SYDNEY WEST CENTRAL PLANNING PANEL BRIEFING REPORT

SWCPP Ref:	2018SWC043
Property Address:	29 Carter Street LIDCOMBE NSW 2141
Proposed Development:	Construction of a mixed use development containing three (3) buildings of a height between 6 and 14 storeys containing 418 residential units and 7 neighbourhood shops over 2 levels of basement car parking within the southern part of the site in "Zone 3". The development will be determined by the Sydney Central City Planning Panel.
DA Number:	DA/174/2018
Applicant:	AUSTRALIA YMCI PTY LTD
Architect:	KANNFINCH
Owner:	AUSTRALIA YMCI PTY LTD
Assessment officer:	Helen Mulcahy

Figure 2. Site Plan showing Building Numbering and Heights

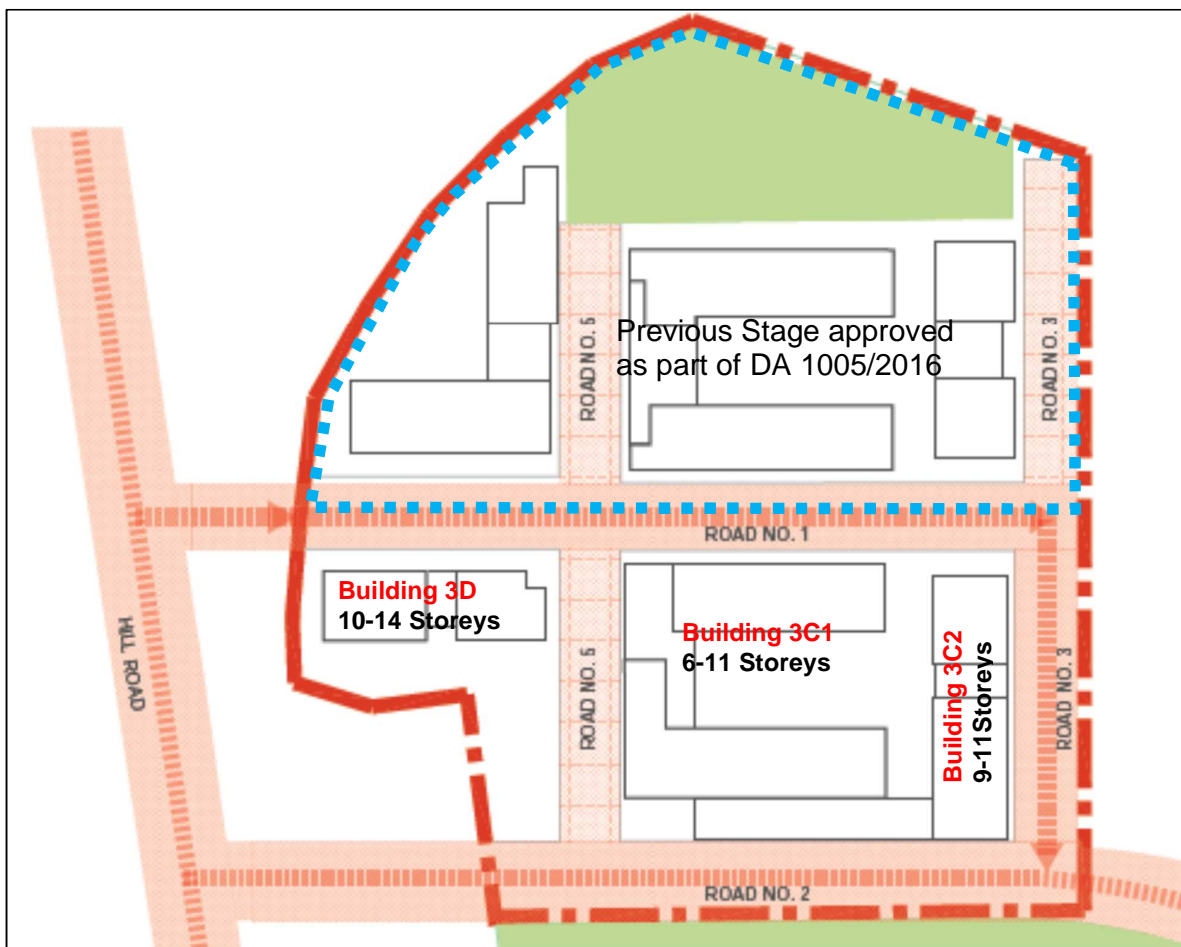
- The Panel notes that the proposal does not accommodate 5m setbacks for built form and basement footprint. The Panel considers and does not accept the argument of existing approvals within the precinct that do not currently comply.*

- The proposal's basement parking, like the aboveground development, extends to all property boundaries, and passes under the streets. The Panel does not support this and recommends providing the 5m setback, as mentioned in the DCP, in order to provide more deep soil planning (sic) along the streetscape and afford a softer street edge. The encroachment under the street is also not supported and the Panel recommends keeping underground parking within each site boundary's setbacks.*

- The proposed building forms are large, long and unrelenting and block sun access and sight lines. The U shaped building's massing (3D1) surrounds a Communal Open Space with continuous buildings on almost all four sides. The Panel recommends breaking up the buildings into smaller blocks that could be designed to better frame the Communal Open Space, provide more permeability through the development and reduce the "fishbowl" effect the current form has on the Open Space.*
